**ABRACON, LLC
ENGINEERING/PROCESS CHANGE NOTIFICATION FORM**

APAM2764YK0175 Rev B

ECN # 3211

GPS Active Internal Patch

PACKAGING

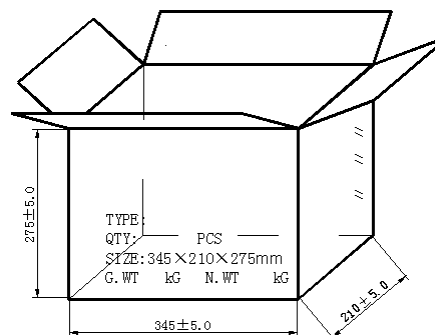
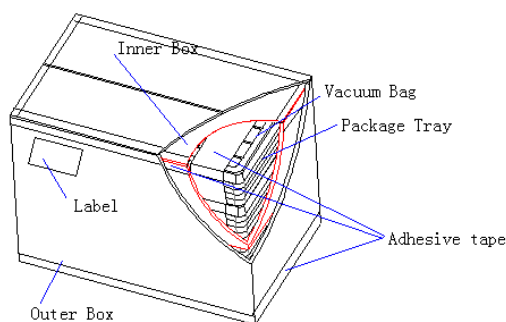
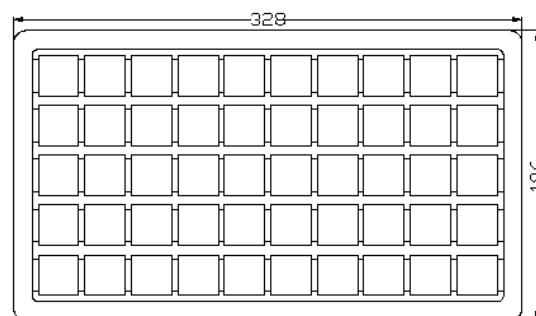
Removed ESD handling, update Proprietary Notice and HQ address, MSL level change, update packaging details, and MOQ, update Cautions, Notes and T&C

Package Type	Quantity
Tray	50 pcs/tray
Vacuum Bag	200pcs/box
Outer Box	1000 pcs/box
